Model: SR3020		Date: 21-Oct-09	No.: RB804001
Subject: Parts catalog correction		Prepared by: M. Kumagai	
From: 1st Tech. Support Sec. Service Support Dept.			
Classification:	<input type="checkbox"/> Troubleshooting	<input checked="" type="checkbox"/> Part information	<input type="checkbox"/> Action required
	<input type="checkbox"/> Mechanical	<input type="checkbox"/> Electrical	<input type="checkbox"/> Service manual revision
	<input type="checkbox"/> Paper path	<input type="checkbox"/> Transmit/receive	<input type="checkbox"/> Retrofit information
	<input type="checkbox"/> Product Safety	<input type="checkbox"/> Other ()	<input type="checkbox"/> Tier 2

Model: AP-C1 Finisher SR3020/3030		Date: 31-Mar-10	No.: RB804002
Subject: Parts information		Prepared by: M. Kumagai	
From: 1st Overseas Tech Support Sec., 1st PQM Dept.			
Classification:	<input type="checkbox"/> Troubleshooting <input checked="" type="checkbox"/> Part information <input type="checkbox"/> Action required <input type="checkbox"/> Mechanical <input type="checkbox"/> Electrical <input type="checkbox"/> Service manual revision <input type="checkbox"/> Paper path <input type="checkbox"/> Transmit/receive <input type=

Stapler Tray (Pg.23 Index#17)

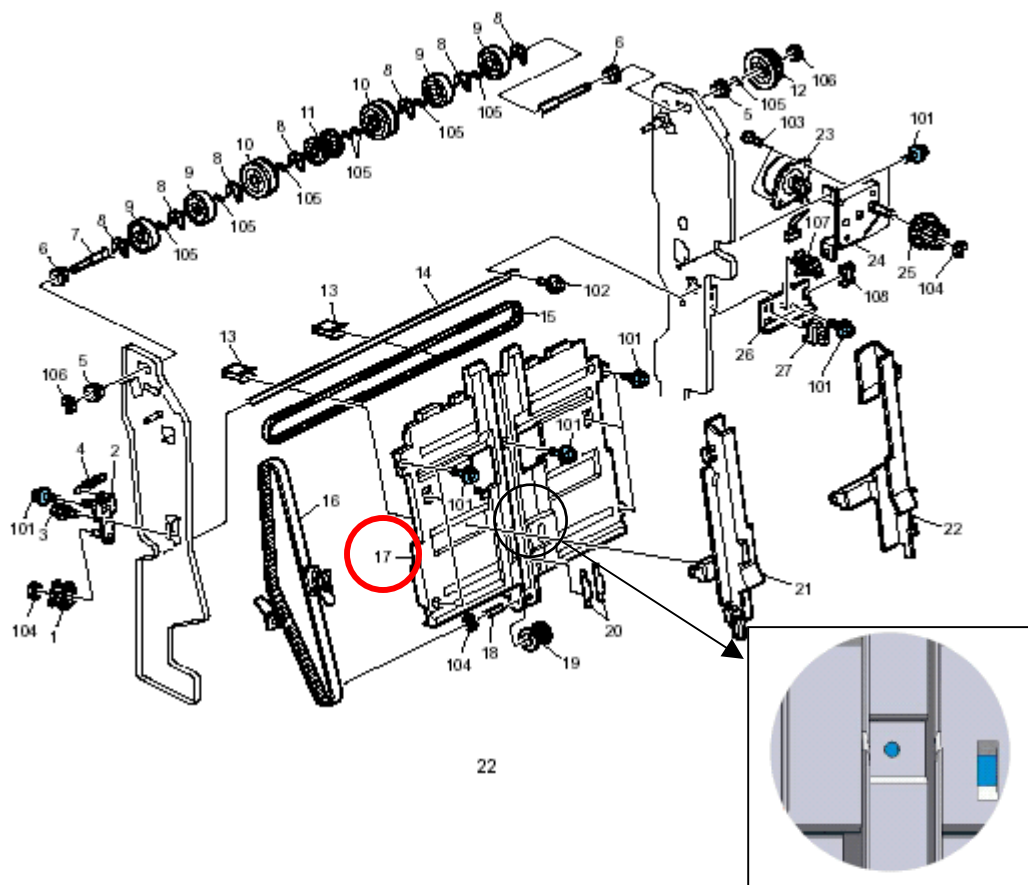
Change: A tapping screw was added for attaching the stapler tray to the lower stay positioning sensor, and screw holes were added as shown below.

Reason: To further improve structural reliability.

Old part number	New part number	Description	Q'ty	Int	Page	Index	Note
B7004180	D3734180	Stapler Tray	1-1	X/X	23	17	X/O as a set
B7004167	D3734167	Stay: Lower: Positioning Sensor	1-1	X/X	29 (B804) 25 (B805)	7	
-	04543006Q	Tapping Screw - M3x6	7-8	-	23	101

15.Staple Tray 6 (B804)

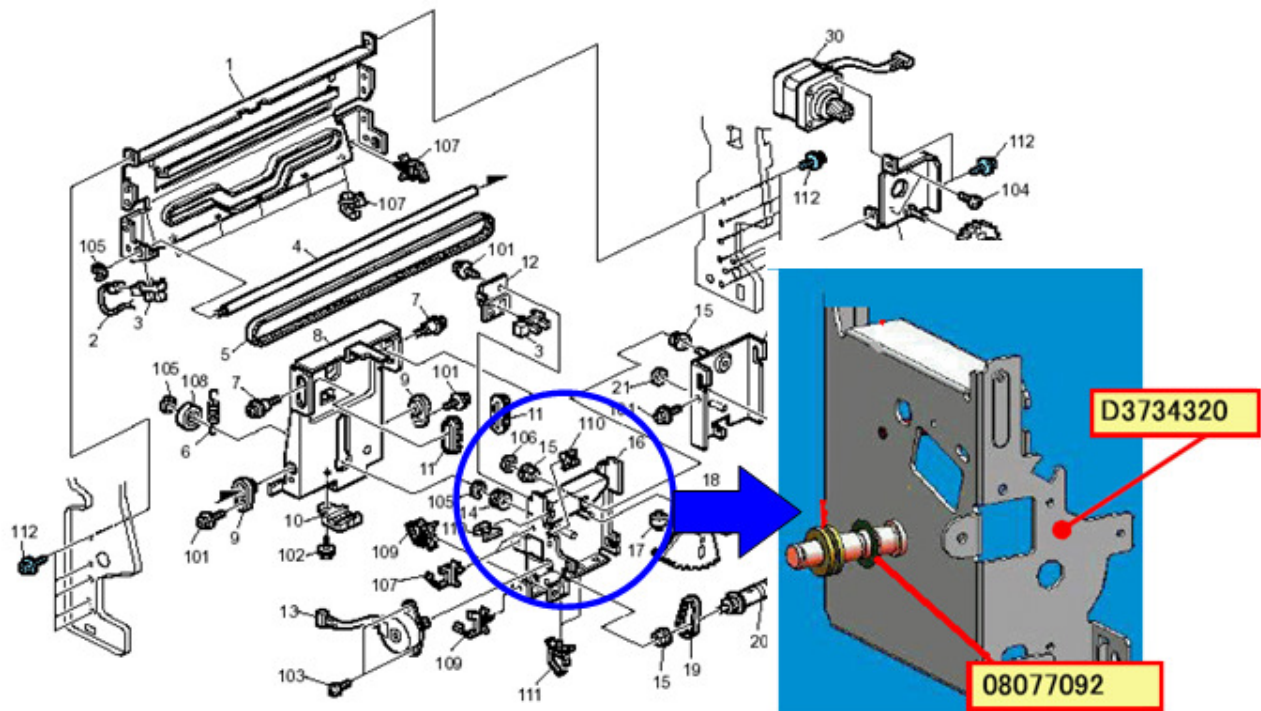
Change: A spacer was added to the shaft of the stapler bracket.

Reason: To improve the reliability of staple positioning.

Old part number	New part number	Description	Q'ty	Int	Page	Index	Note
B7004320	D3734320	BRACKET:STAPLER:SLIDE:ASS'Y	1	X/O	31	16	
	08077092	SPACER - 10.5/16	1		31	114*

The affected stapler unit is shown in the illustration below (Index #24):

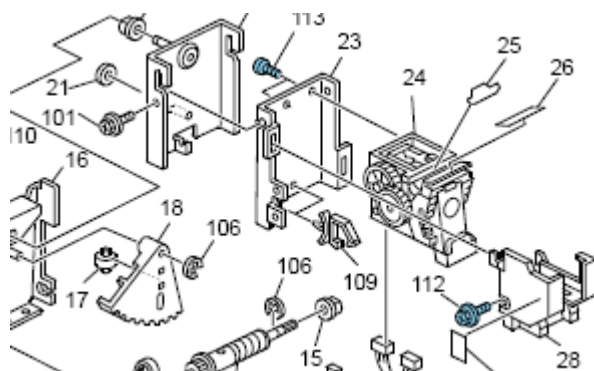
Some parts of the stapler unit (black resin parts shown below) contained PBDE material in excess of the limits set by the RoHS Directive.

The vendor of these parts used irregular materials during the manufacturing process.
 Production period: June to September 2010 (refer to the S/N table below)

Replace the stapler unit.

Replace the affected stapler units with the following part numbers for the intended models

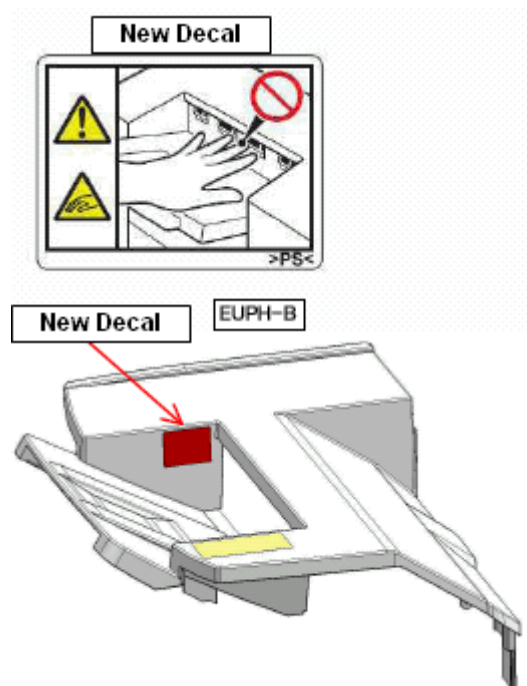
Change/Reason: A new decal was added to improve product safety

Old part number	New part number	Description	Q'ty	Int	Page	Index	Note
	B8047813	DECAL:CAUTION:PROOF TRAY:PAPER EXIT SUB-UNIT	1
